RE: Skelton Pit, File No. M-2022-019, Construction Materials Regular (112), Application Adequacy Review

Please accept this letter on behalf of United Companies as the response to the Adequacy Review, dated June 15, 2022 for the Skelton Pit. Outstanding items and questions are addressed below.

Map C-1

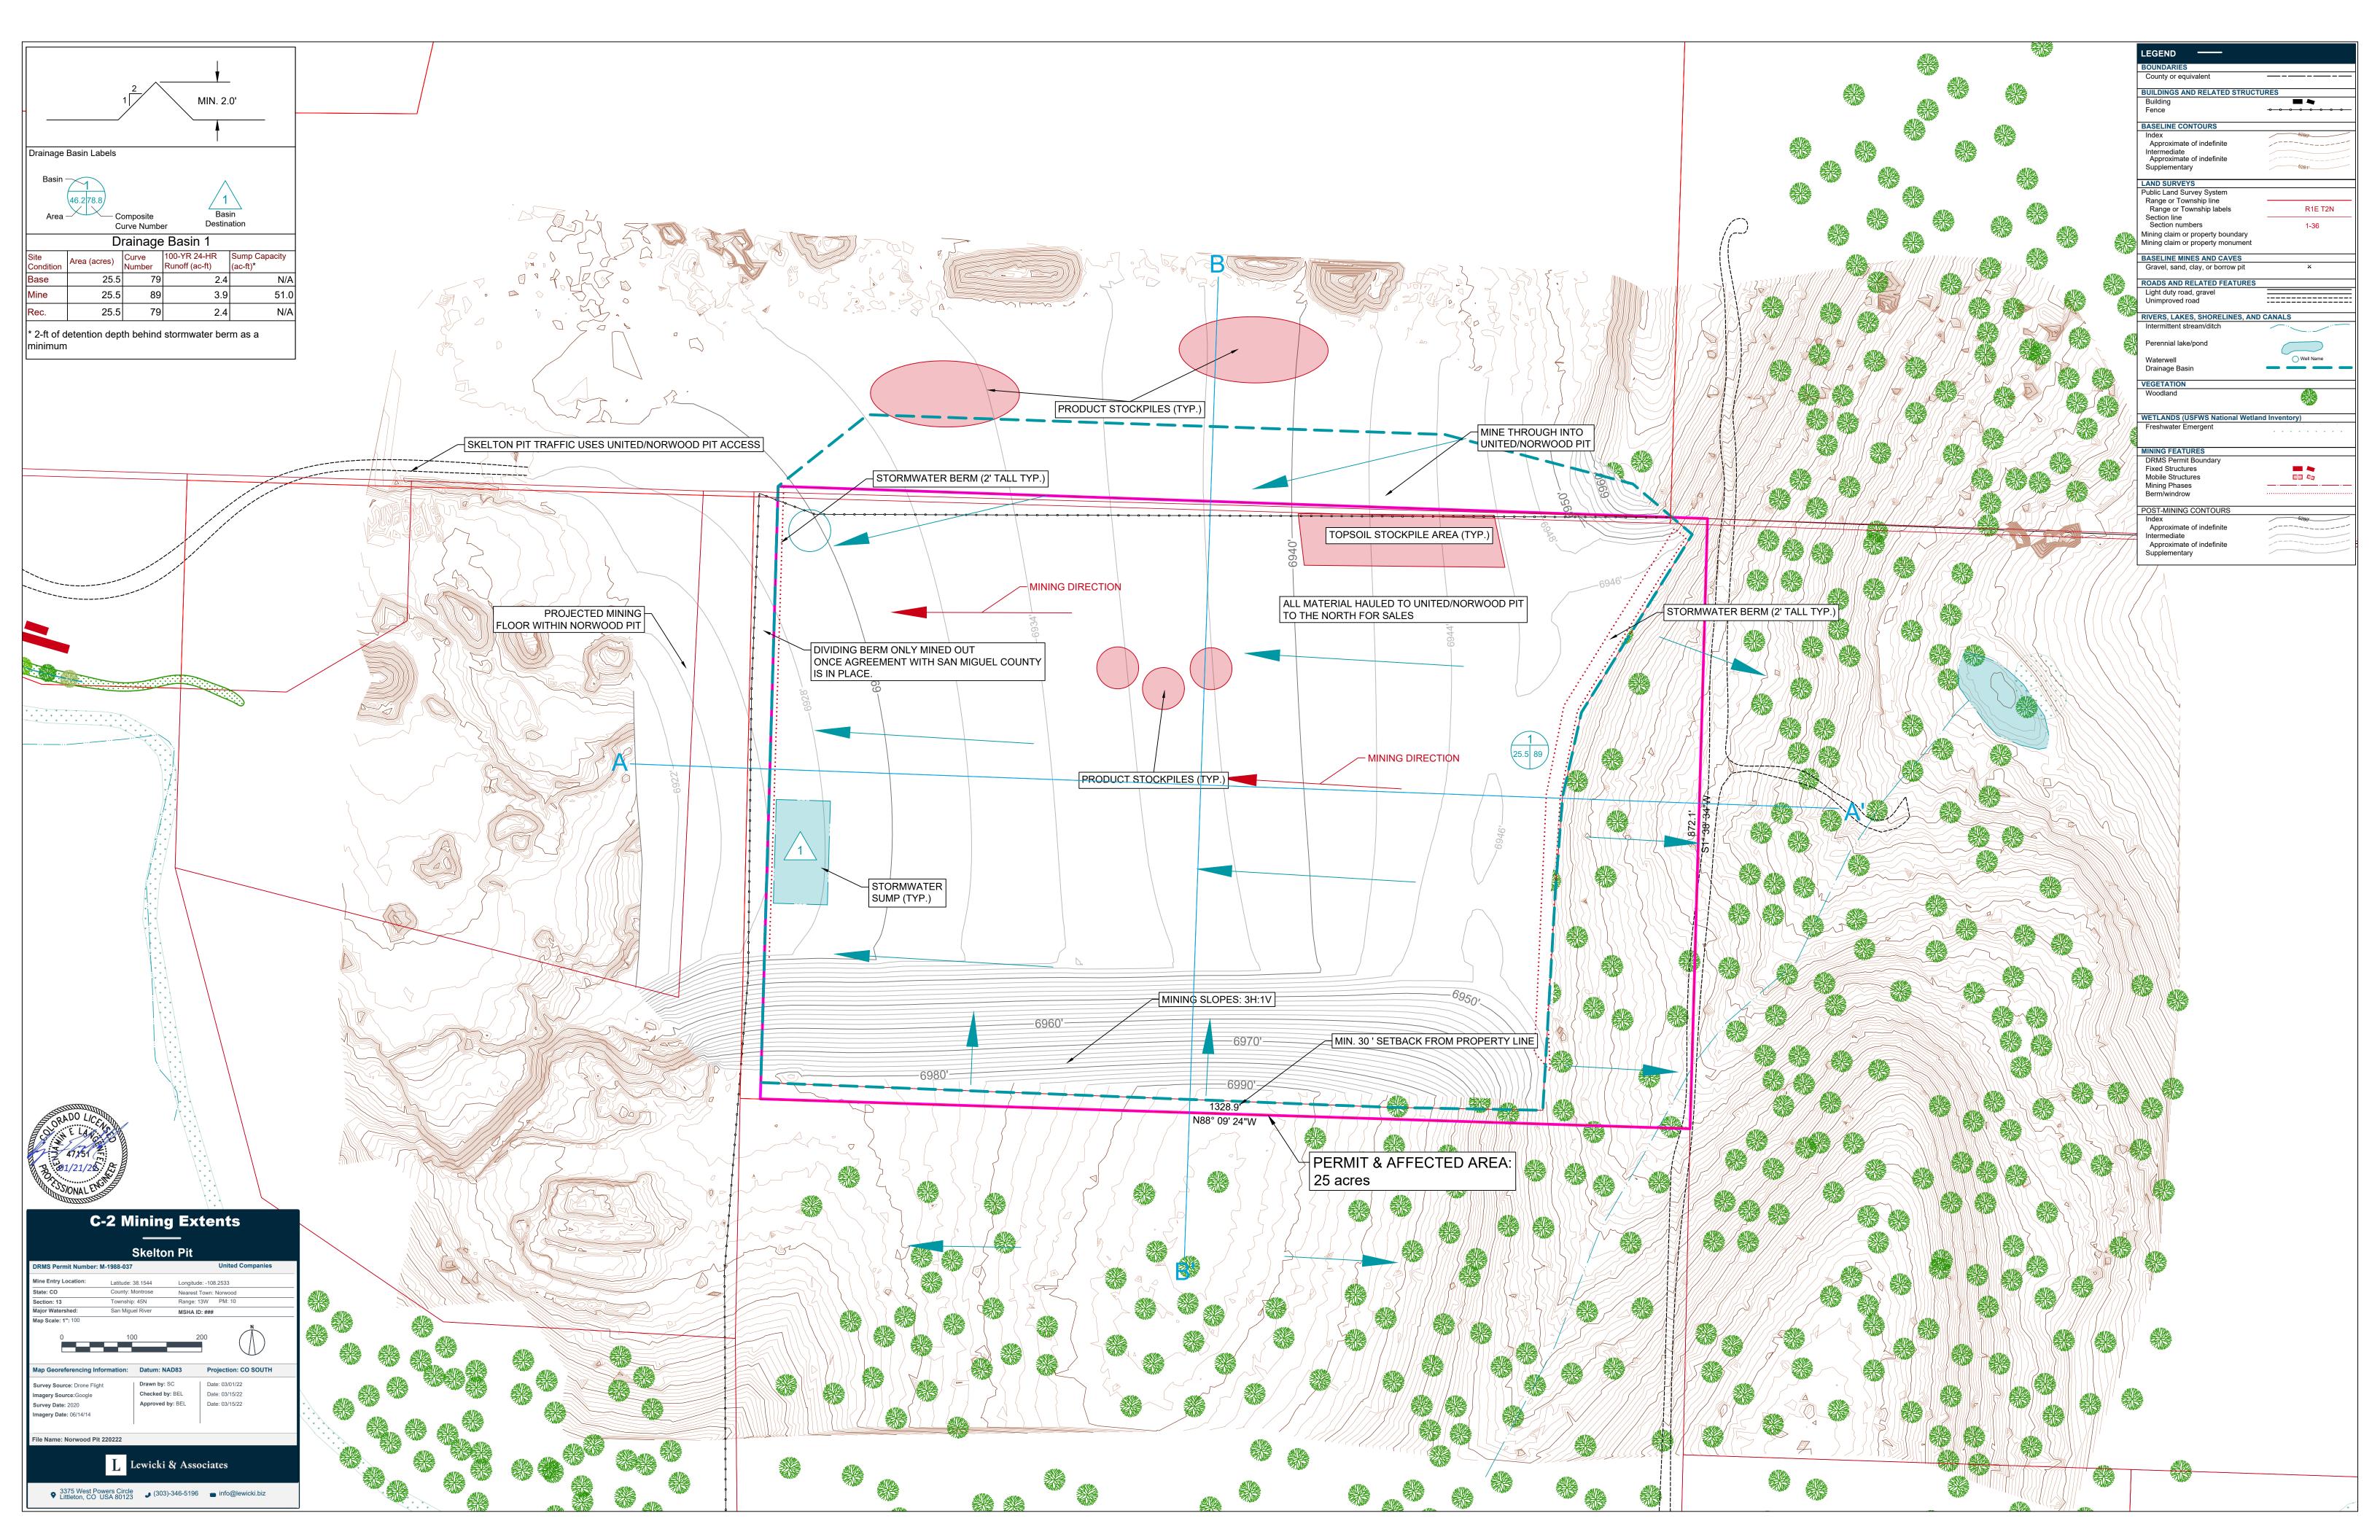
2. <u>Exhibit C- Pre Mining and Mining Plan Map(s)-Rule 6.4.3:</u> Map C-1 "Baseline Condition" did not include the type of vegetation covering the affected lands. Though discussed and documented with photographs in Exhibit J, Please revise Map C-1 to include this information pursuant to Construction Materials Rule 6.4.3(e).

Please see the revised Map C-1 with the vegetation coverage and type documented.

Map F-1

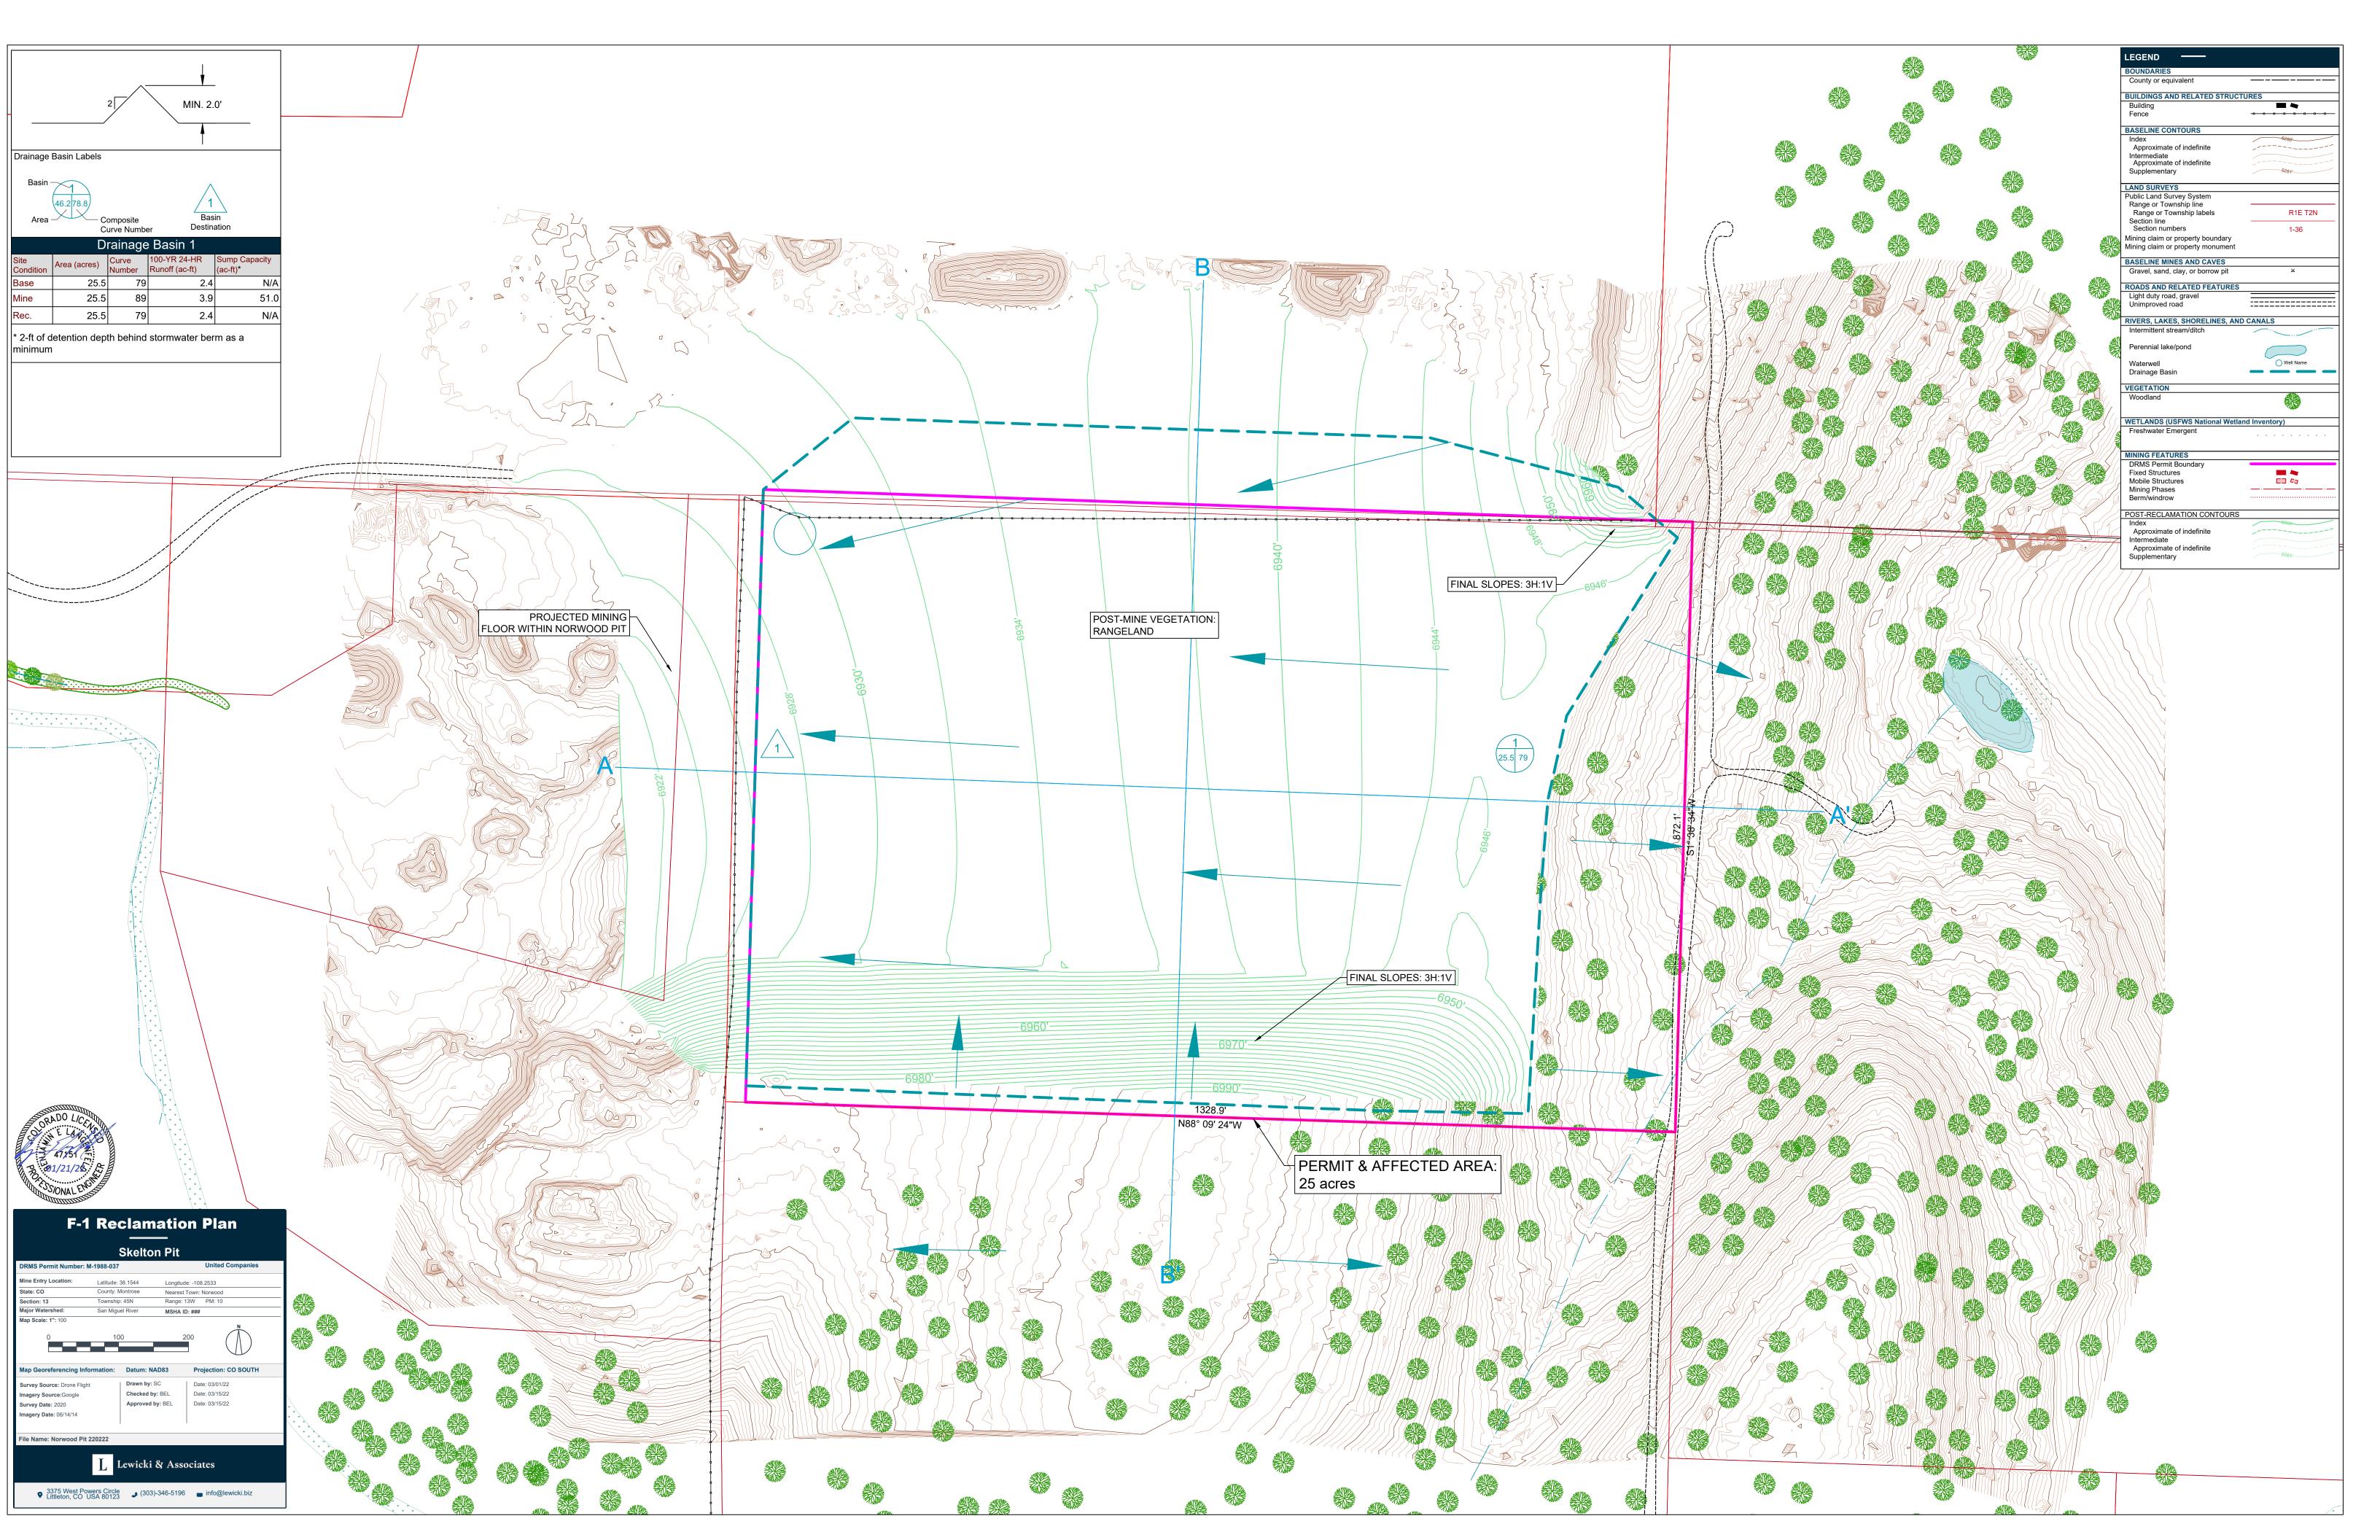
5. Exhibit F- Reclamation Plan Map- Rule 6.4.6: Map F-1 appears to show 3 post-reclamation drainage basins however no such details are included in the narrative of Exhibit E. Please discuss these features in the narrative including their use, size and location. If these features are incorrectly included in the Reclamation Plan Map and are not to be considered post-reclamation features, please revise Map F-1 to remove them.

Each map shows the drainage conditions for the site at that stage. As there is only one drainage basin, each map only shows the drainage conditions for that one basin. A table has been added to Exhibit G comparing the drainage conditions onsite before, during, and after mining for CDRMS convenience.

Note that the drainage basins delineated on each map are not stormwater control structures. They are the bounded area that drains into or through the site. Stormwater control berms are drawn and labelled separately on Map C-2.
